Access Compliance Report

Public Rights-of-Way

(Pedestrian Signals)

Intersection ID: N/A	Main Street:	Cross Street: N/A	Location: N/A
ADA ID: F687EAFEBD50	Signal Type: One Push Button-APS	Overall Compliance: No	Severity Score: BTN 1: N/A BTN 2: N/A No BTN: N/A
Codes/Mitigation Info/Possible Solution		Field Measurements/Component Compliance

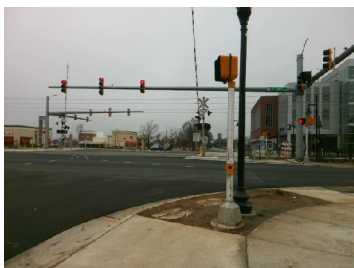
N/A	B 1 FWD Approach Width (in)	N/A	N/A	B 2 FWD Approach Width (in)	N/A
N/A	B 1 FWD Approach Obstruction?	Yes	N/A	B 2 FWD Approach Obstruction?	N/A
N/A	B 1 FWD Approach Obstruction Dist (in)	4.0	N/A	B 2 FWD Approach ObstructionDist (in)	N/A
N/A	B 1 PARA Approach?	Yes	N/A	B 2 PARA Approach?	N/A
N/A	B 1 PARA Approach Constrained?	Yes	N/A	B 2 PARA Approach Constrained?	N/A
Yes	B 1 PARA Approach Reach (in)	10.0	N/A	B 2 PARA Approach Reach (in)	N/A
No	B 1 PARA Approach Width (in)	48.0	N/A	B 2 PARA Approach Width (in)	N/A
N/A	B 1 PARA Approach Obstruction?	Yes	N/A	B 2 PARA Approach Obstruction?	N/A
N/A	B 1 PARA Approach Obstruction Dist (in)	4.0	N/A	B 2 PARA Approach ObstructionDist (in)	N/A
No	B 1 Clear Floor Space Slope (%)	7.0	N/A	B 2 Clear Floor Space Slope (%)	N/A
No	B 1 Clear Floor Space XSlope (%)	3.4	N/A	B 2 Clear Floor Space XSlope (%)	N/A
N/A	B 1 PAR Slope (%)	N/A	N/A	B 2 PAR Slope (%)	N/A
Yes	B 1 Height (in)	41.0	N/A	B 2 Height (in)	N/A

Possible Solutions: Remove & Replace
Replace APS Button With New APS Button.
Remove and Replace Clear Space.

PROW/ADA: R404.2, R404.3, R404.7.2,
R209.1, MUTCD 4e.10
